Staff Report

Historic Review of New Construction

New Mixed-Use Development in Monteith National Register Historic District

File No. **HI-04-20**

1
 AO.1
 SITE PLAN
 SCALE 1/8" = 1'-0"

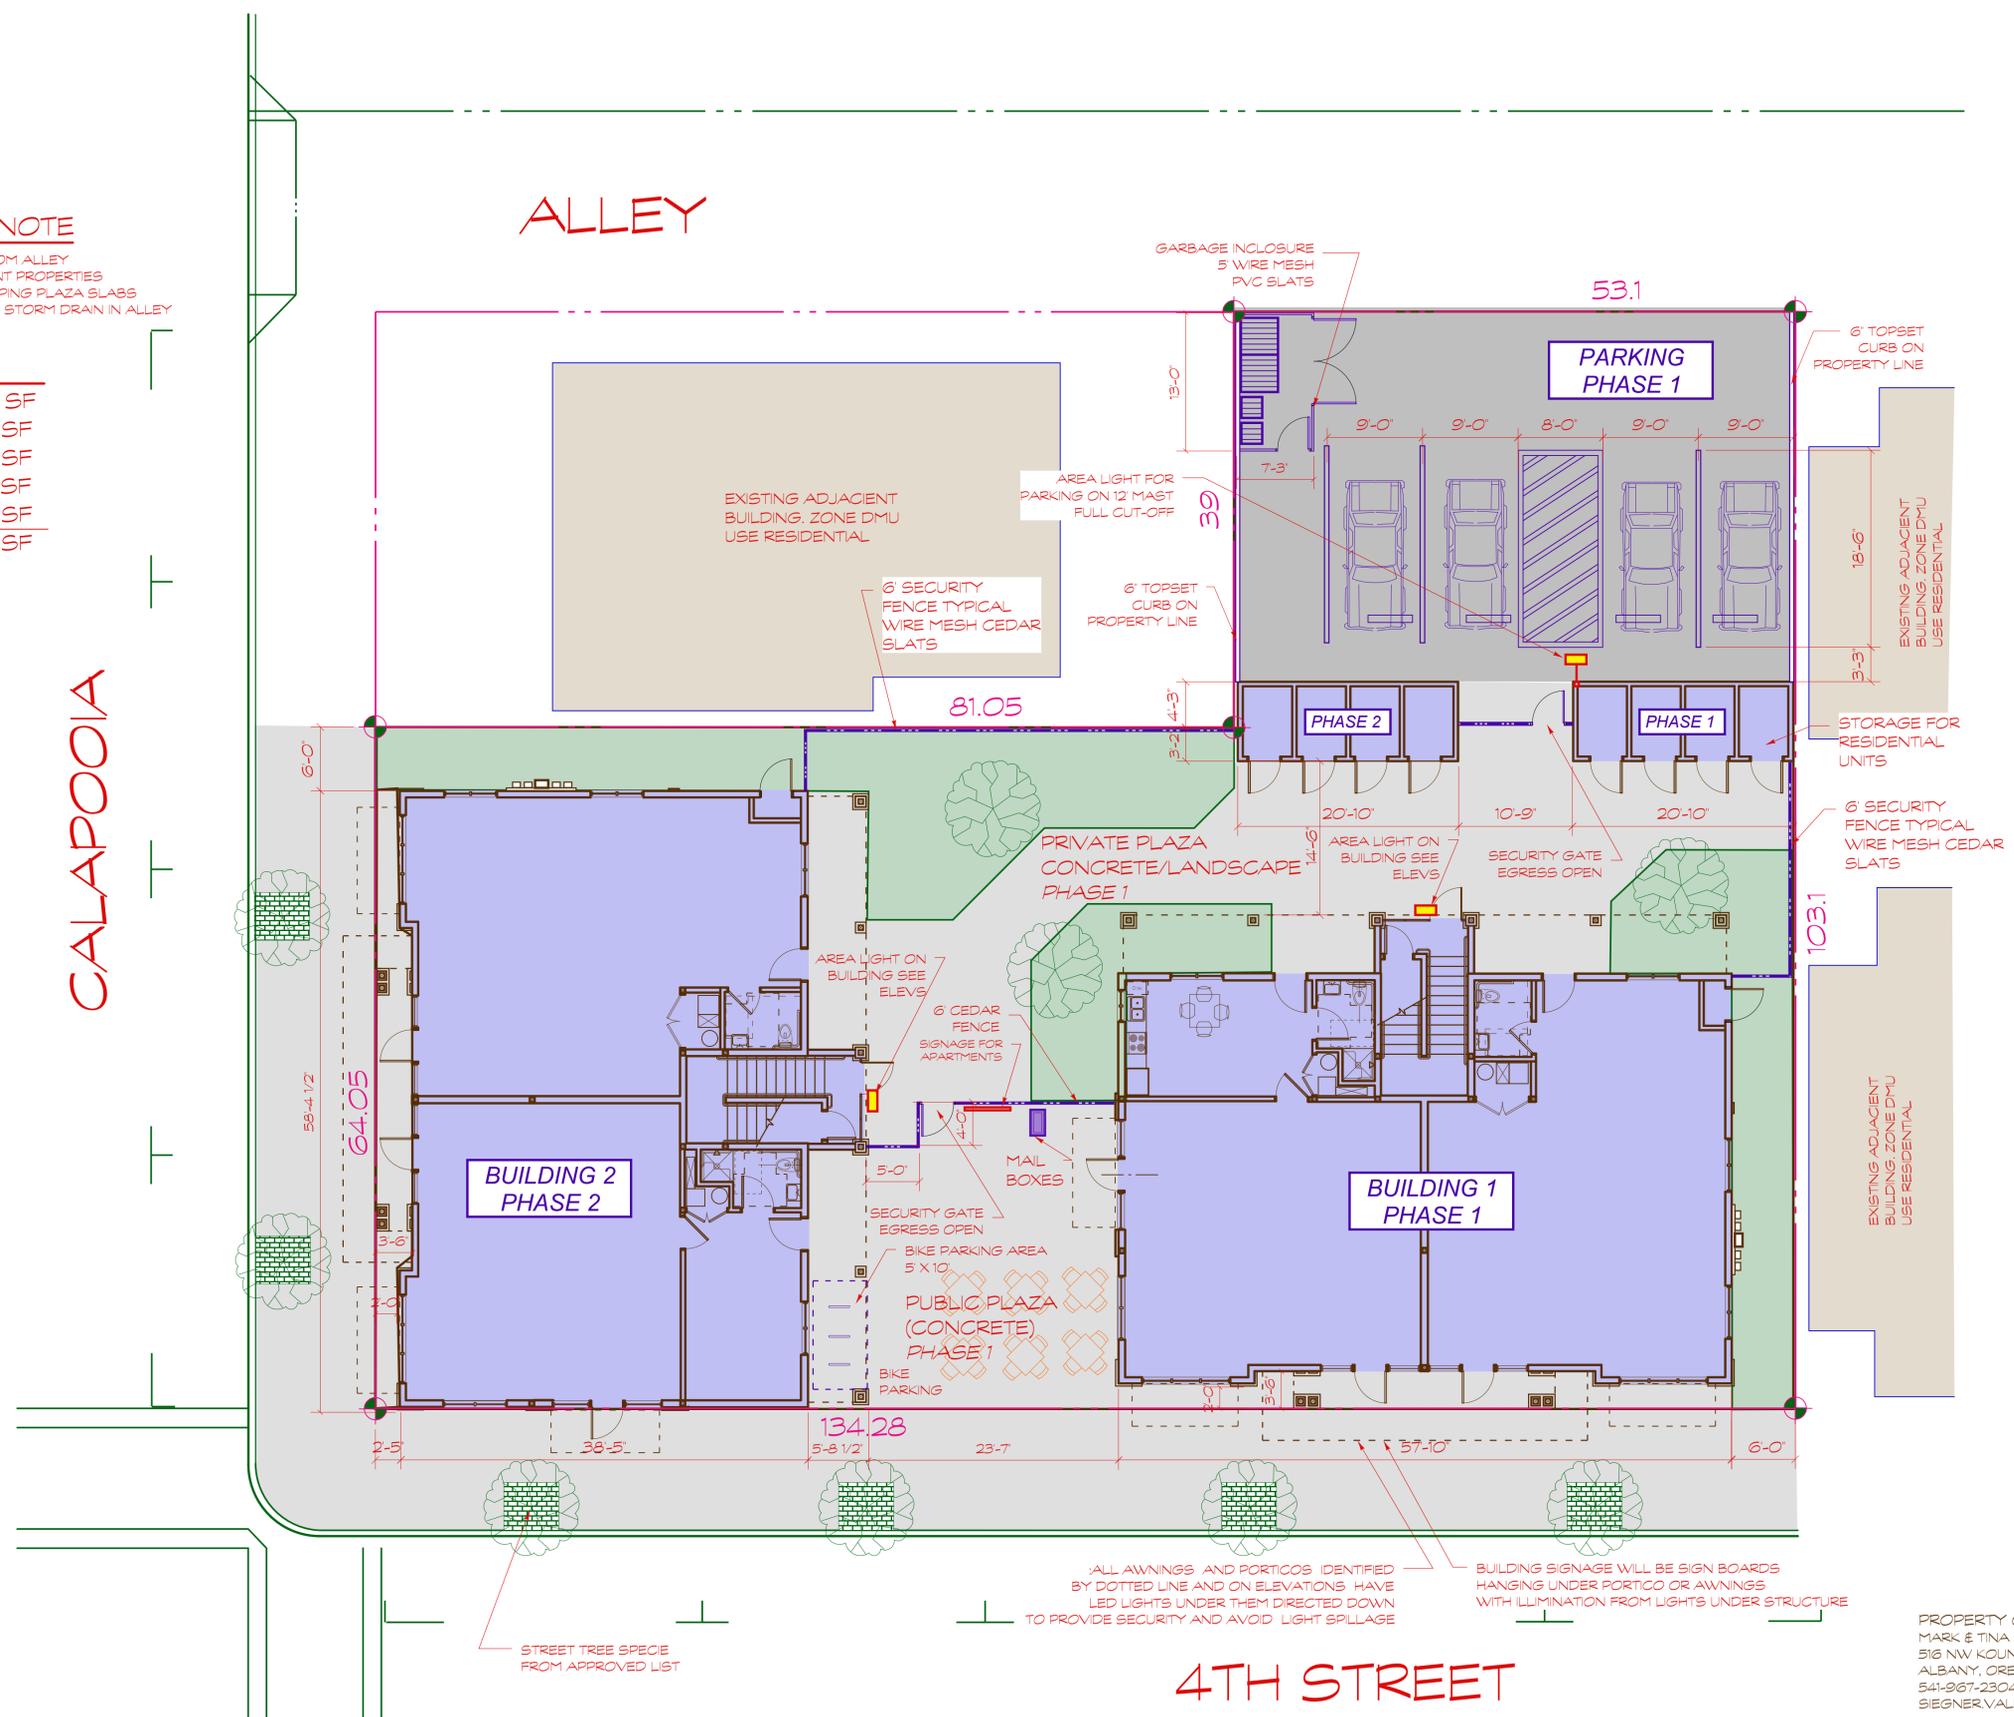
- 1.10 Building One has a variable setback of 2-feet to 3-feet-6-inches from the Fourth Avenue (south) front property line; a 6-foot setback from the east interior property line abutting a historic residential dwelling; a 62-feet-5-inch setback from the alley and 23-feet-five-inches setback from the northern interior property line abutting a historic residential dwelling; and a 70-foot setback from the Calapooia Street (west) property line (see Attachment B.1).

Building Two has a variable setback of 2-feet to 3-feet-6-inches from the Calapooia Street (west) front property line and zero setback from the Fourth Avenue front property line; a 6-foot setback from the north interior property line abutting a historic residential dwelling; and a 93-foot setback from the east interior property line abutting a historic residential dwelling (see Attachment B.1).

The residential storage units have zero setback from the east and west interior property lines; a 35-foot setback from the alley (north) property line; and a 60-foot setback from Fourth Avenue (south) front property line (see Attachment B.1).

- 1.4 The front setbacks of Building Two along Calapooia Street comply with the maximum setbacks of the DMU zone but would result in a disorderly development pattern along Calapooia Street block face. A condition of approval will ensure that the front setback of Building Two along the Calapooia Street block face is brought into closer alignment with the structure at 323 Calapooia Street in order to maintain a unified development pattern.

- Condition 2* Prior to issuance of a building permit for Building Two, the applicant shall submit a revised site plan to the Community Development Department for review and approval that places the front setback of Building Two no more than five feet closer and no more than five feet farther from the main wall of the abutting structure at 323 Calapooia Street SW, along the Calapooia Street (front) property line.
